# PIC16C774 Rev. B Silicon Errata Sheet

The PIC16C774 (Rev. B) parts you have received conform functionally to the Device Data Sheet (DS30275**A**), except for the anomalies described below.

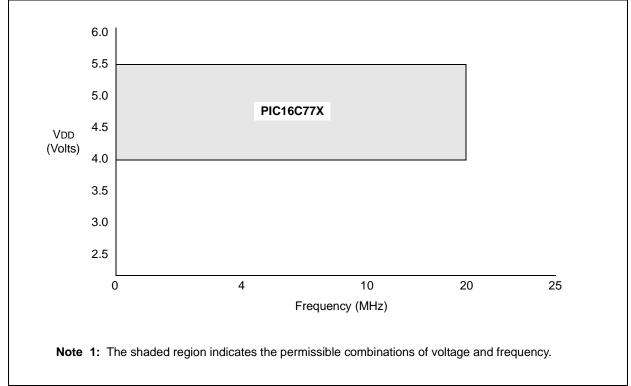
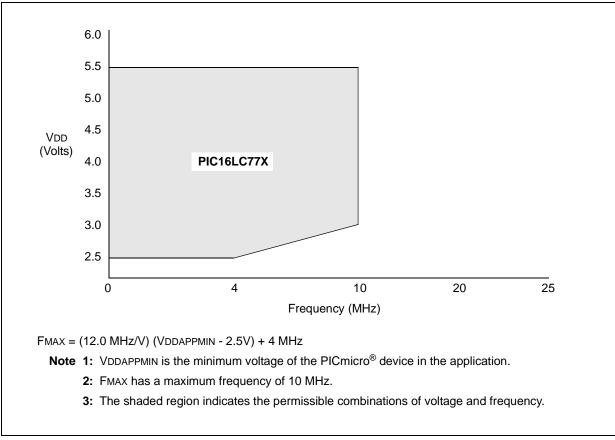
Table 15-1 in the Device Data Sheet (DS30275A) should be omitted. Figure 15-1 and Figure 15-2 below should be used to determine the operating voltages and frequencies for the devices.

# PIC16C774 PRODUCT IDENTIFICATION SYSTEM

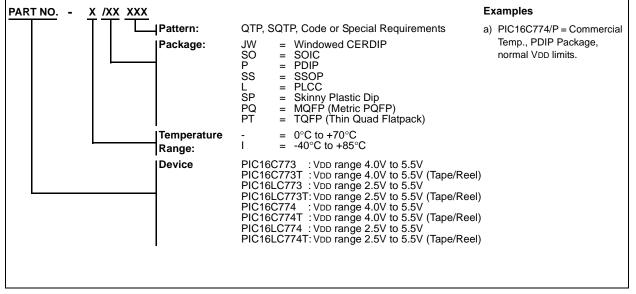
The details of the new Product Identification System are given below. This information replaces the Product Identification System details given in the Device Data Sheet (DS30275A).
